Field Modification Note

075063500

REFERENCE ECO: 156G

KALYPSO

Figure 1. 2-M/E Control Panel SCSI Connector

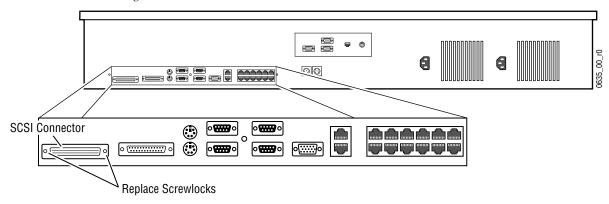
- **1.** Turn off power to the Kalypso control panel by opening the lid and turning off the power supplies.
- **2.** Locate the SCSI connector on the rear of the 2-M/E panel (Figure 1) or 4-M/E panel (Figure 2).

- **3.** Remove the SCSI cable by loosening the jackscrews holding it in place.
- **4.** Examine the screwlocks installed in the connector to determine if they are flush with the end of the connector. If the screwlocks extend beyond the end of the connector, the new screwlocks provided with this kit should be installed.
- **5.** Remove the existing screwlocks with a nut driver and install the new ones provided.

- **6.** Make sure the new screwlocks are flush with the SCSI connector and reinstall the SCSI cable. Verify that the cable connection is secure.
- **7.** Turn power back on to the control panel.
